**DRAWING CHANGE NOTICE:** DATE: 12-10-96  
PROJECT NAME: VILLAGE 11/12 UNIT 2B IMPROVEMENTS PASEO PARKWAY  
JOB NO. 62011.213  
DCN NO.  
AGENCY NO.

SUMMERLIN  
VILLAGE 11/12  
UNIT 2B IMPROVEMENTS  
DRAWING CHANGE NOTICES #2

SHEET 46B  
SHT 46B OF 46

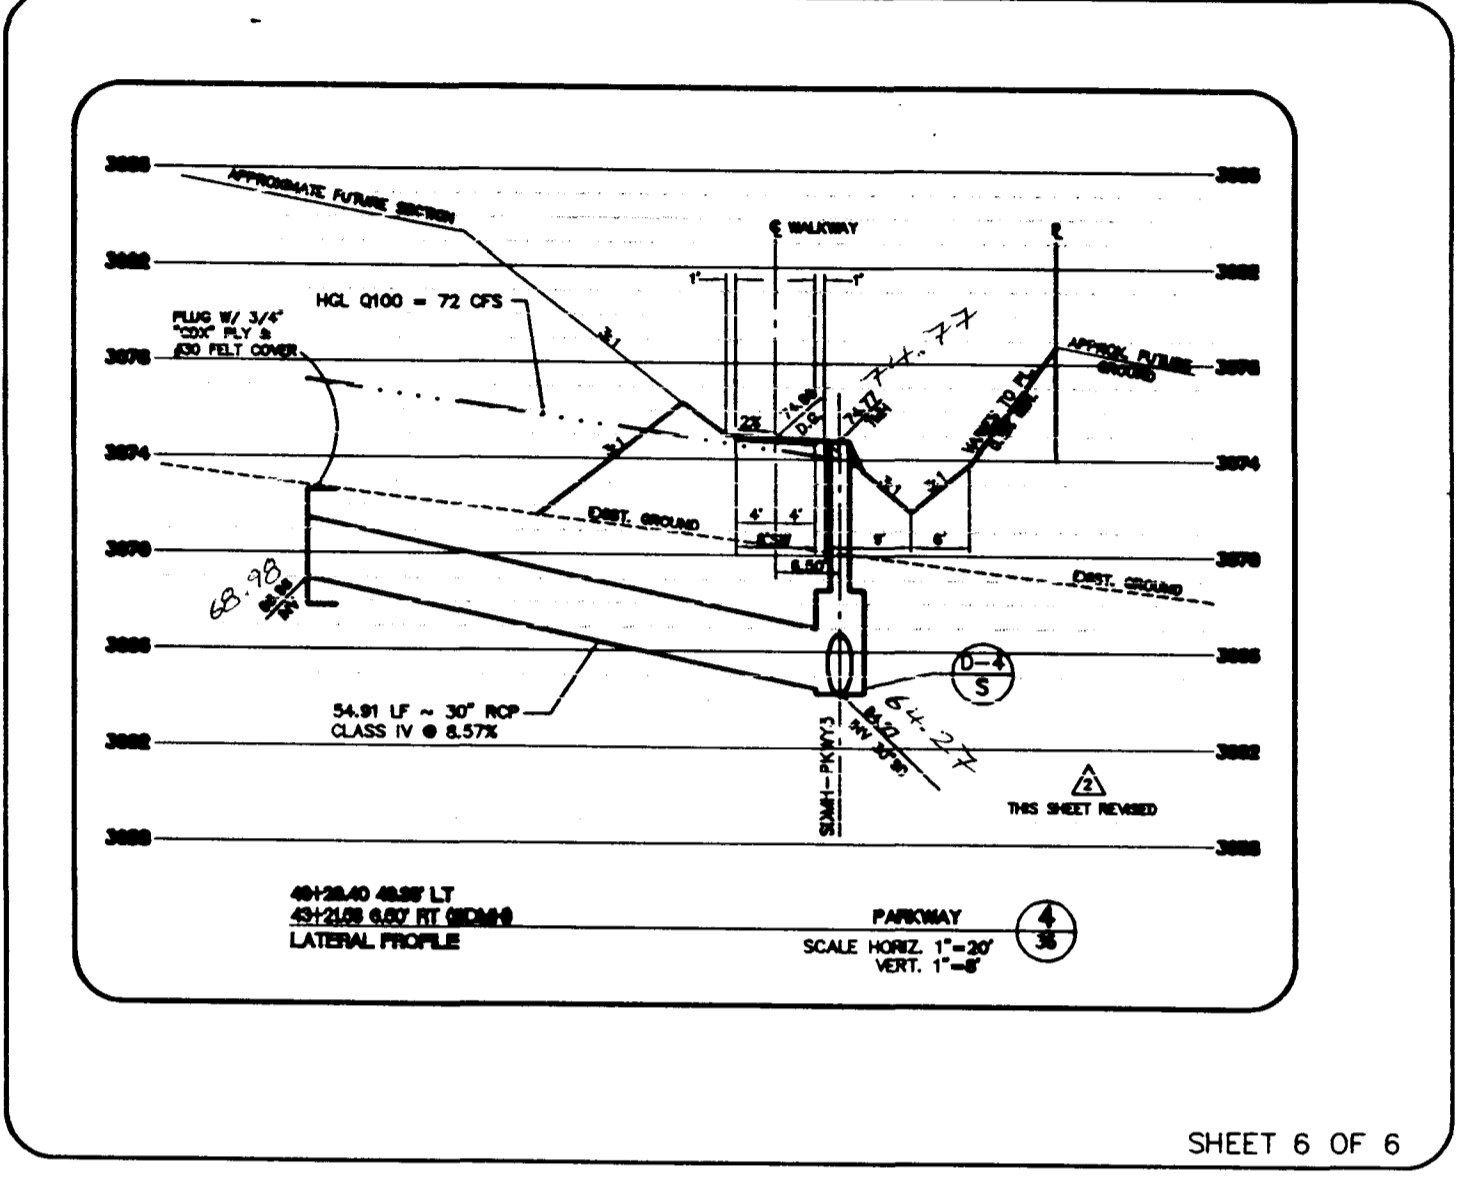
REVISION DESCRIPTION: REVISE SEWER AND STORM DRAIN STUBS FROM PASEO PARK INTO VILLAGE 11/12 - PARCELS R/S PER DEVELOPER REQUEST.

**DRAWING CHANGE NOTICE:** DATE: 01-03-97  
PROJECT NAME: VILLAGE 11/12 UNIT 2B IMPROVEMENTS PASEO PARKWAY - ARCH CULVERT HEADWALL NORTH SIDE OF LAURELGLLEN DR.  
JOB NO. 62011.213  
DCN NO.  
AGENCY NO.

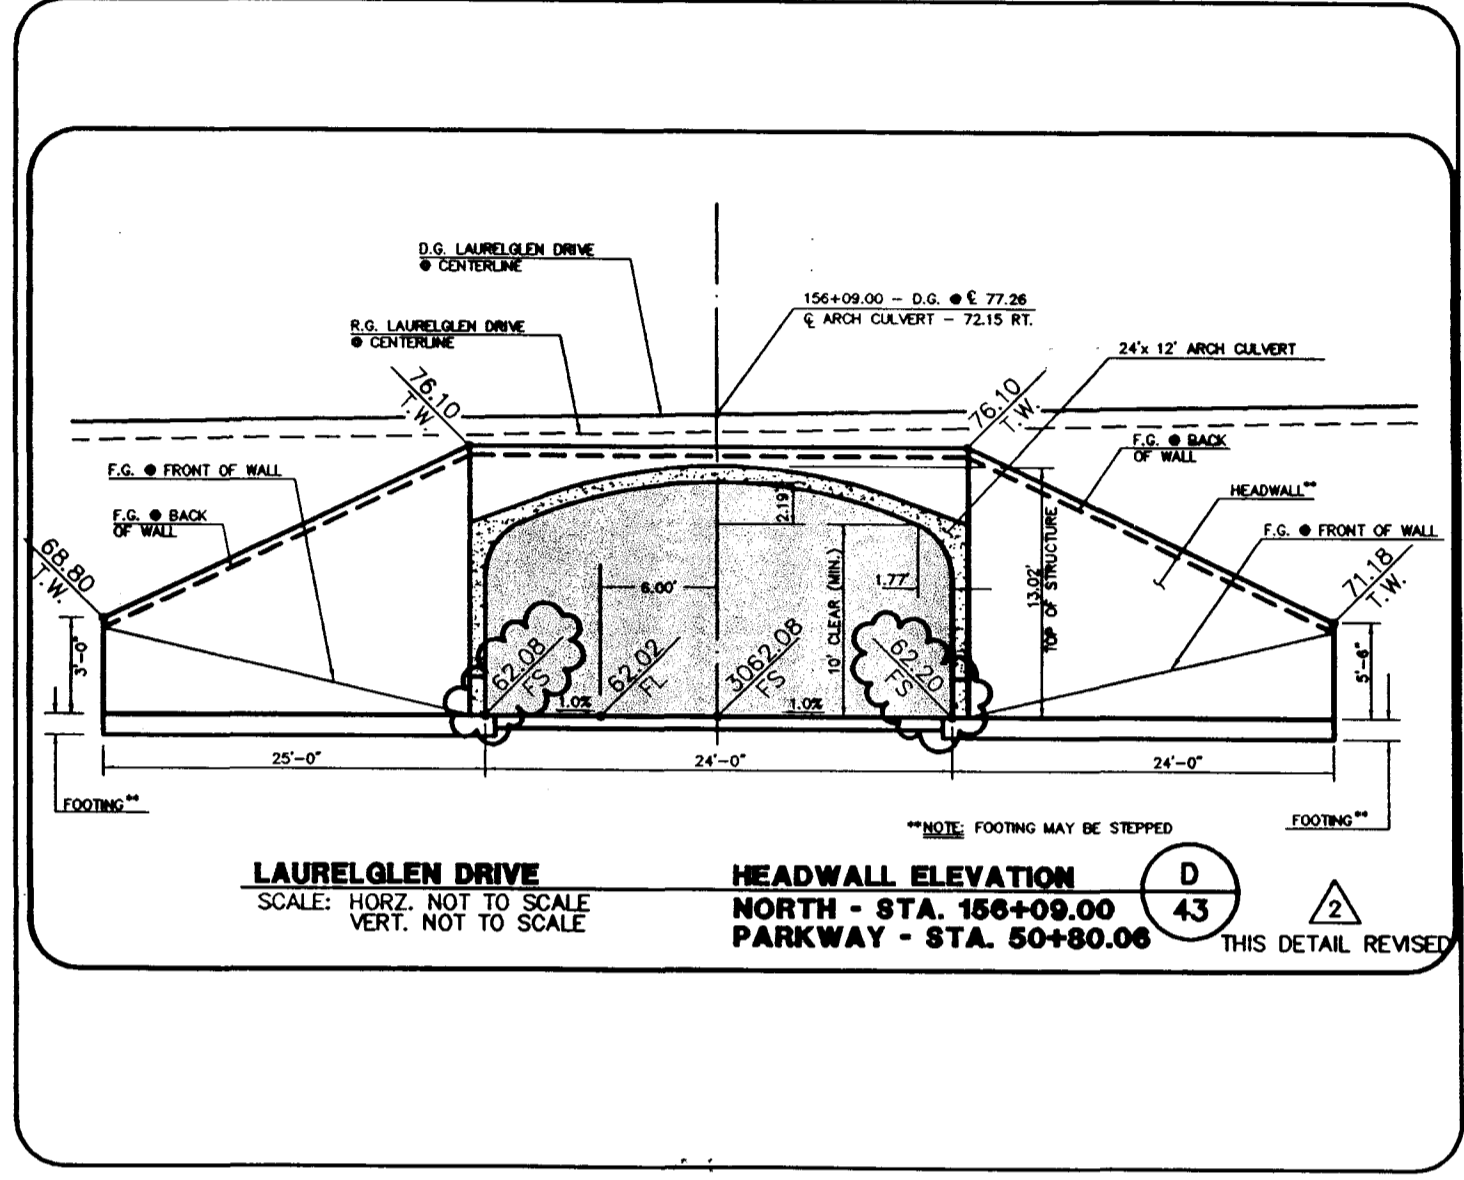
REVISION DESCRIPTION: REVISE F.S. CALL-OUT (LEFT SIDE THIS DETAIL) FROM 62.08 TO 62.08. REVISE F.S. CALL-OUT (RIGHT SIDE THIS DETAIL) FROM 62.08 TO 62.20.

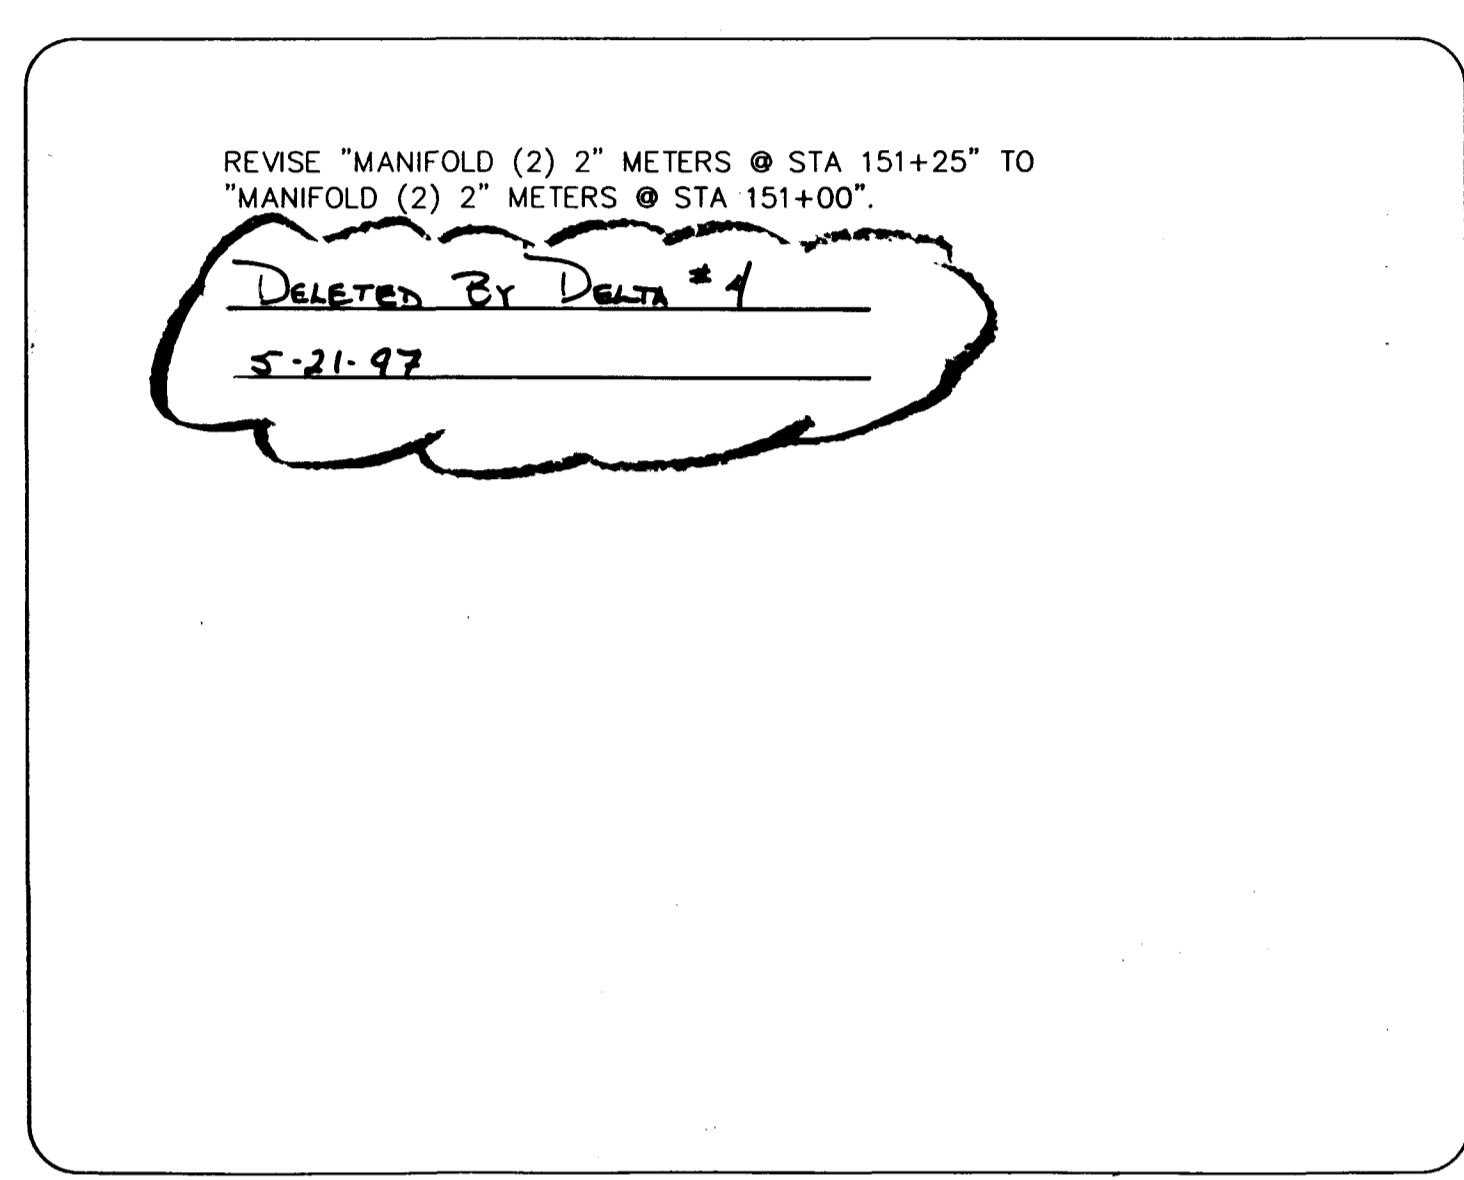
REVISION DESCRIPTION: REVISE STATION CALL OUT FOR THE TWO 2" IRRIGATION METERS ON LAURELGLLEN DRIVE SHEET 20 FROM STA 151+25 TO 151+00.

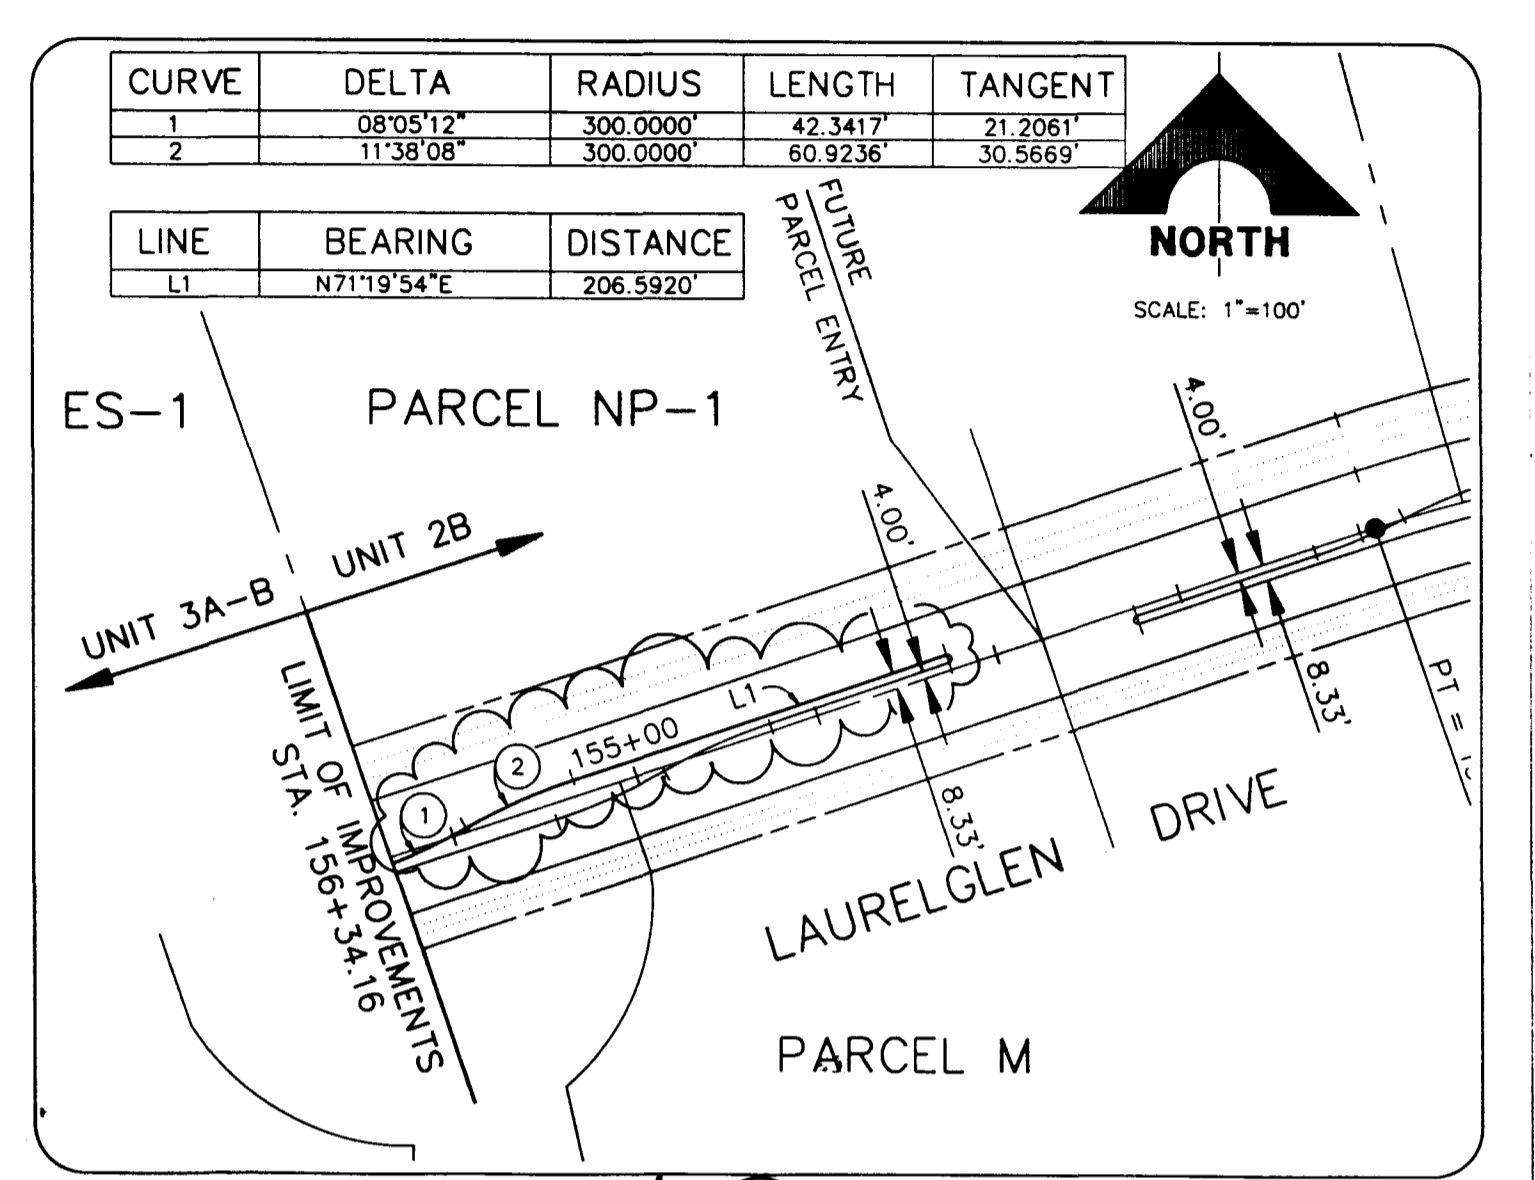
REVISION DESCRIPTION: REVISE MEDIAN CURB ON LAURELGLLEN UNIT 2B (SHEETS 4 & 21) DUE TO THE PARCEL ENTRY SHIFT OF THE HINDU TEMPLE SITE ALONG LAURELGLLEN UNIT 3A-B.

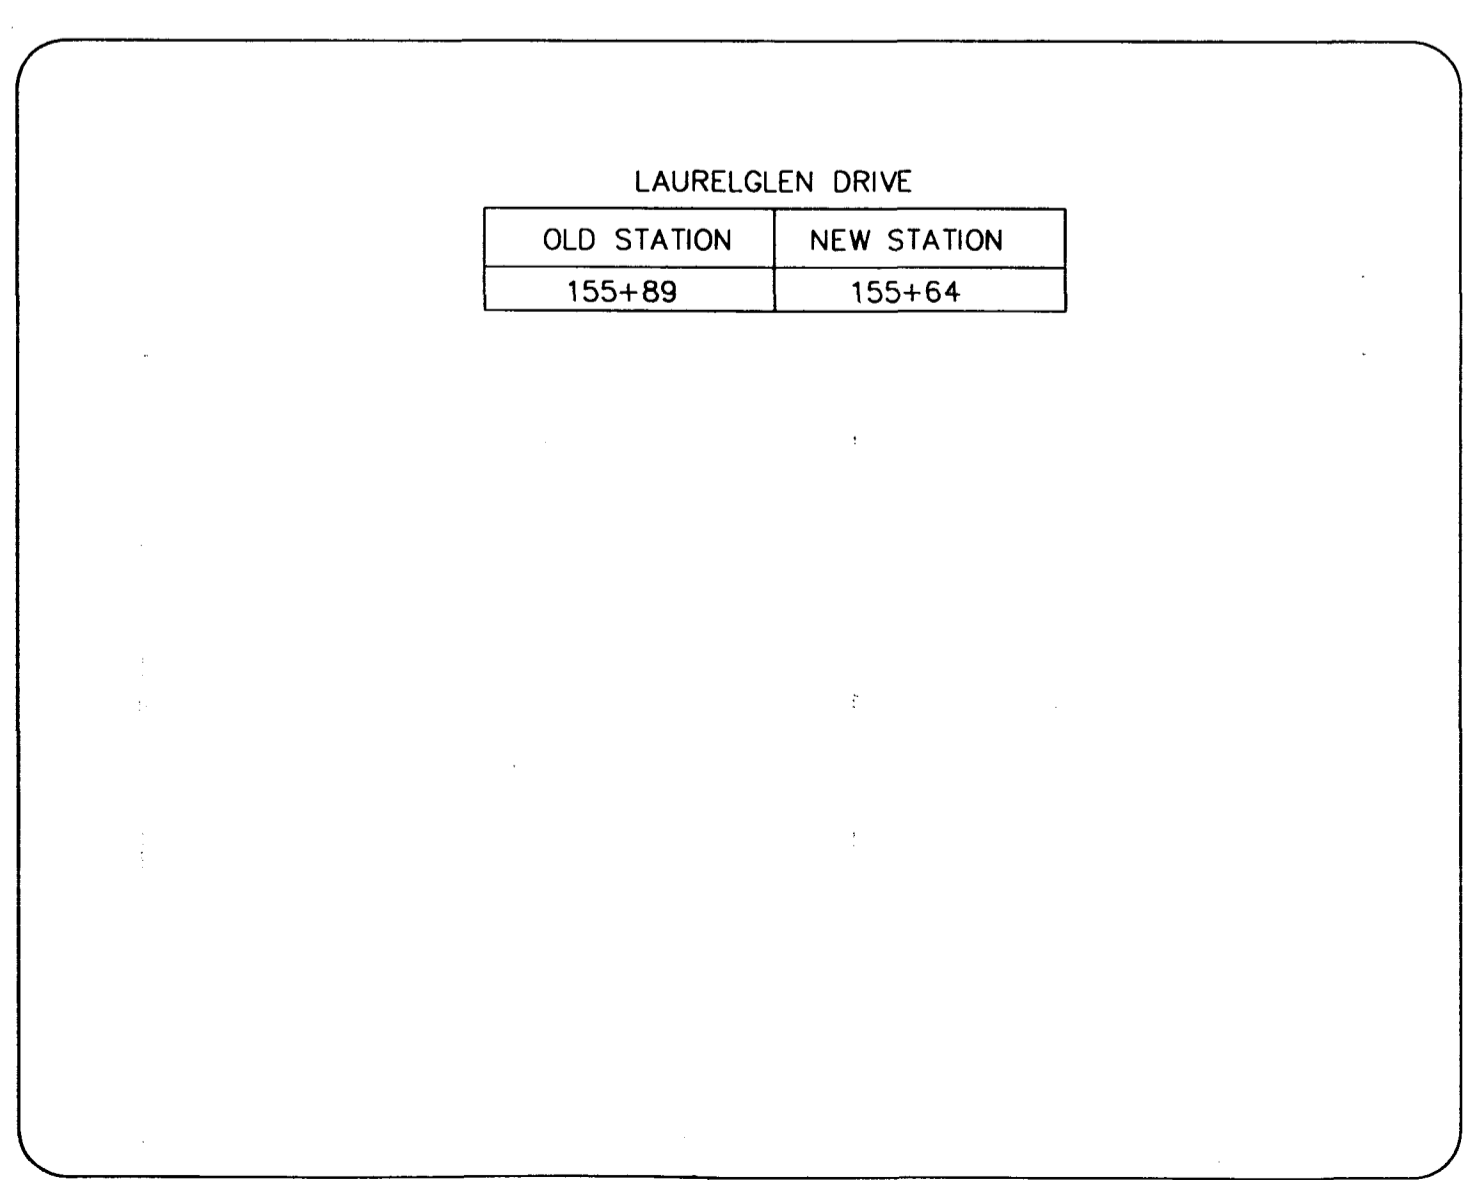
REVISION DESCRIPTION: RELOCATE STREET LIGHT ON LAURELGLLEN DRIVE, UNIT 2B IMPR. DUE TO HINDU SITE ENTRY RELOCATION ON UNIT 3A-B IMPR.

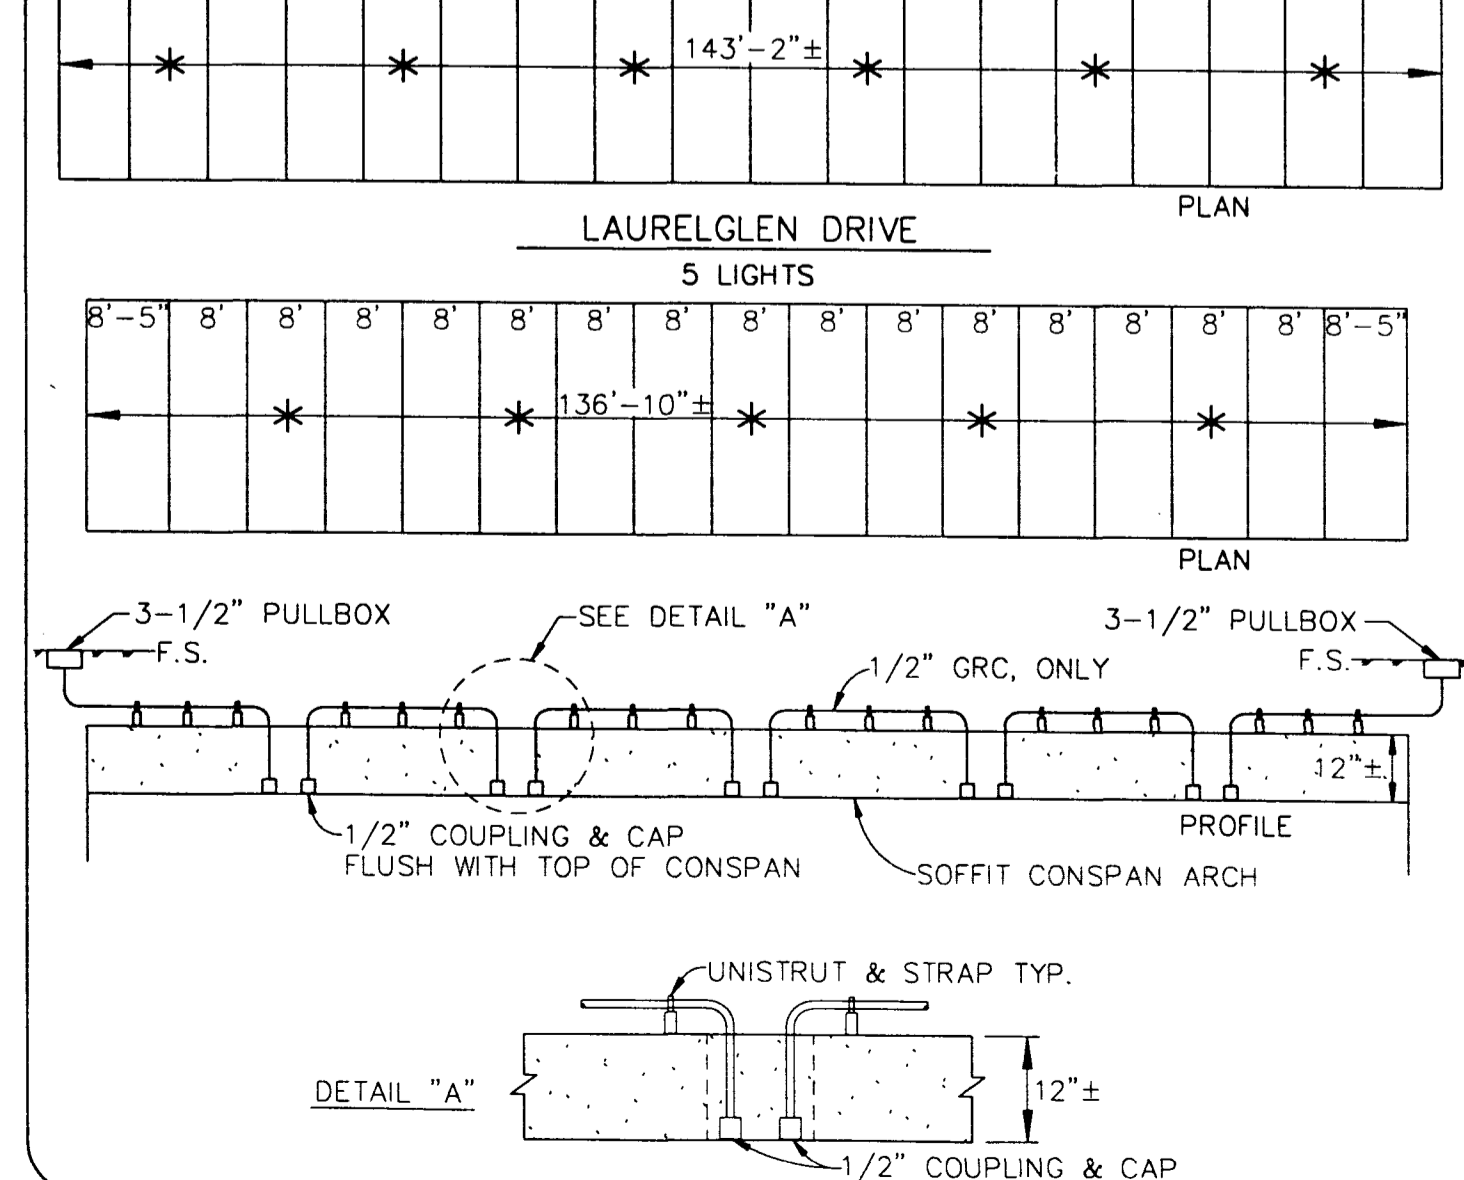
REVISION DESCRIPTION: CONSPAN (ARCH CULVERT) CONDUIT LAYOUT
